# **US HL-LHC Accelerator Upgrade Project**

# Report of the MQXFA04 Structure and shim Review

12/12/2019

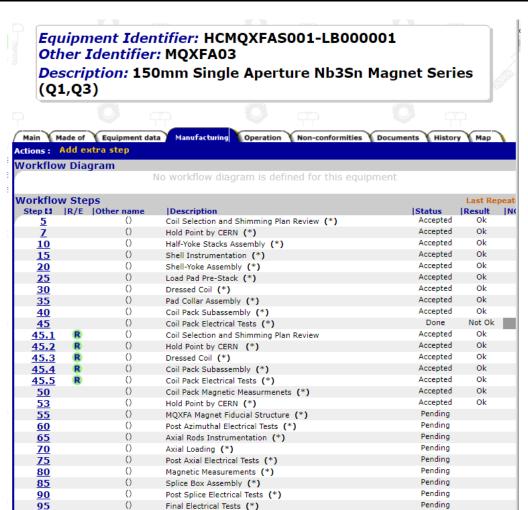
Report overall status and non-conformances to CERN using a similar scheme to the one followed for the coils (monthly excel spreadsheet AUP\_coil\_status) and verify that MTF steps are fully accepted. In the case of MQXFA03, all operations after coil pack magnetic measurements are still pending (see screenshot below).
